CERTIFICATE OF APPROPRIATENESS

Property: 14 Shadow Lawn Street, Lots 14 & 15, Shadowlawn Neighborhood Subdivision. The property includes a historic 2,650 square foot, three-story masonry single-family residence and detached garage situated on a 34,782 square foot (160' x 264') semi-circular lot with three-view points on all sides of the property.

Proposal: Alteration – Addition

****DRAFT STAFF REPORT IS SUBJECT TO CHANGE (REDUCE GARAGE)****

PROPOSED – NORTH VIEW (**SUBJECT TO CHANGE GARAGE)

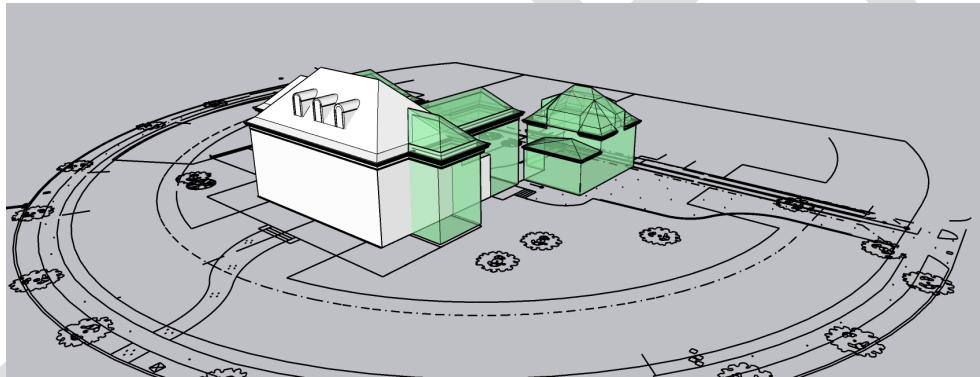
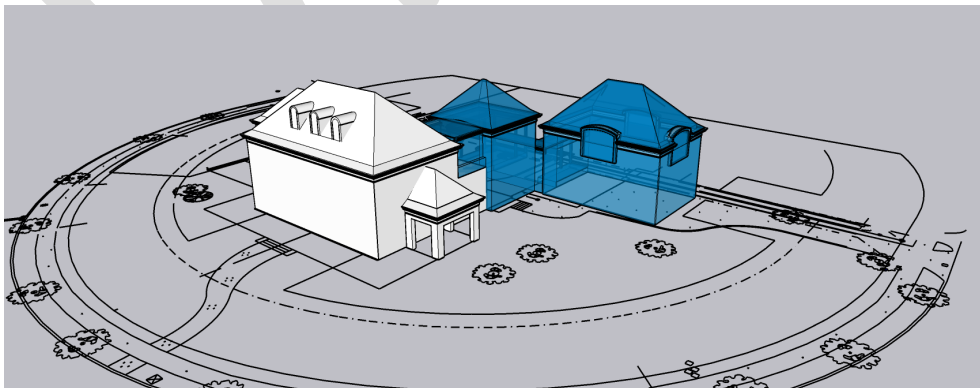
Personally, I am most concerned about the large scale of the new garage and its effect on the John Staub house next door since it will, it appears will be in front of that home. It also appears that the existing garage is shown much taller than it actually is. This garage change will be very significant to the current appearance of the home. This large tall garage to my eyes is out of scale to the original historic home.

This home is at the entrance to the subdivision, facing everyone that enters the circle. It is in my opinion, a very beautiful historic home, and one of the best traditional styled homes in the neighborhood. I would hate, if the new garage moved the focus of this historic home away from the beautiful home to this large tall garage.

ROOFPLAN

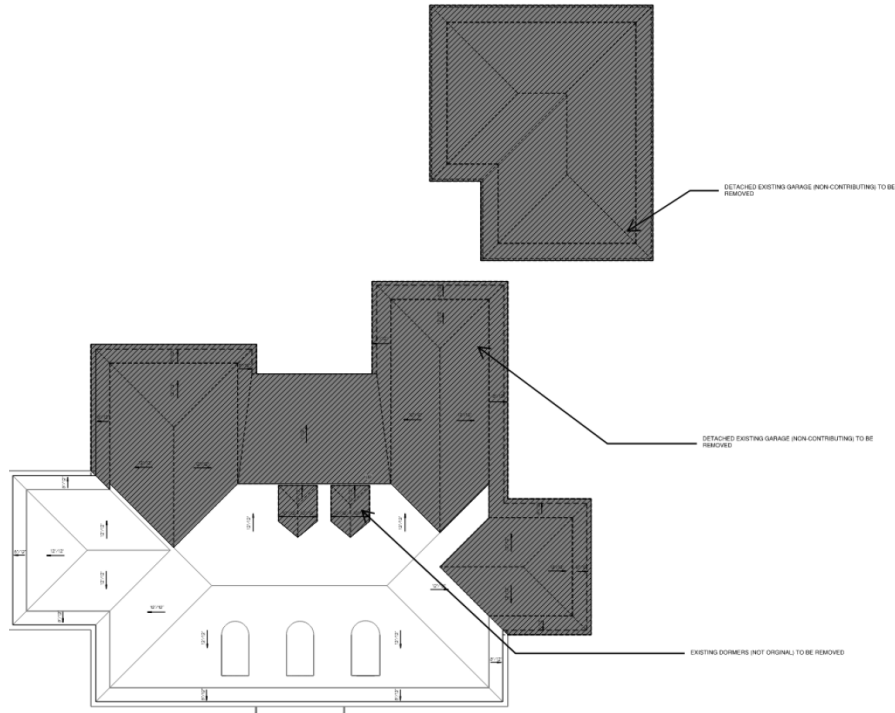
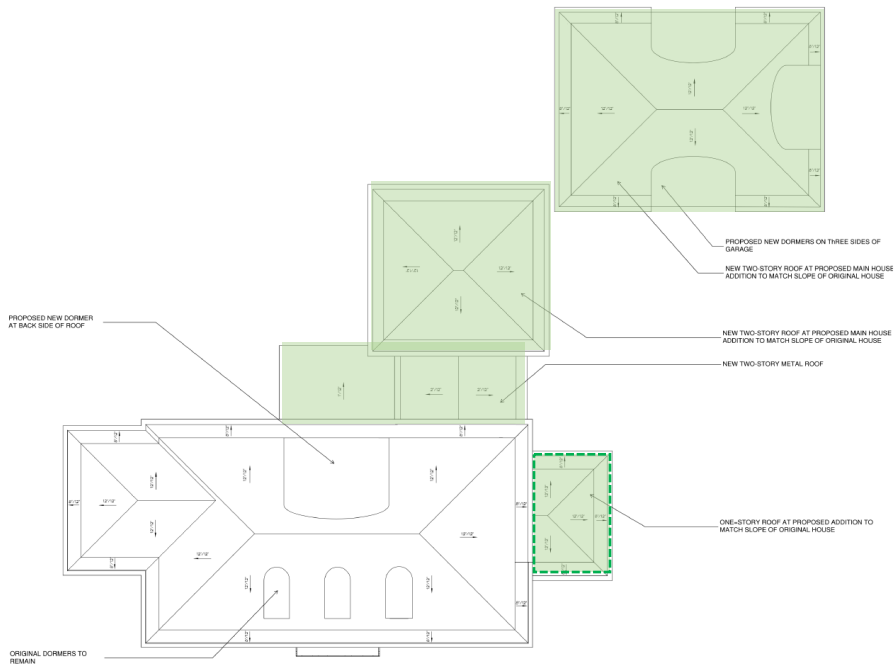
Finally, the drawings call out for a new copper roof to replace the one that is there. Although called out as copper, the existing roof appears from a distance to be slate, but it is difficult to tell. The ridge corner flashings do appear to be copper. Slate roofs are on at least 5 of the homes in the district.
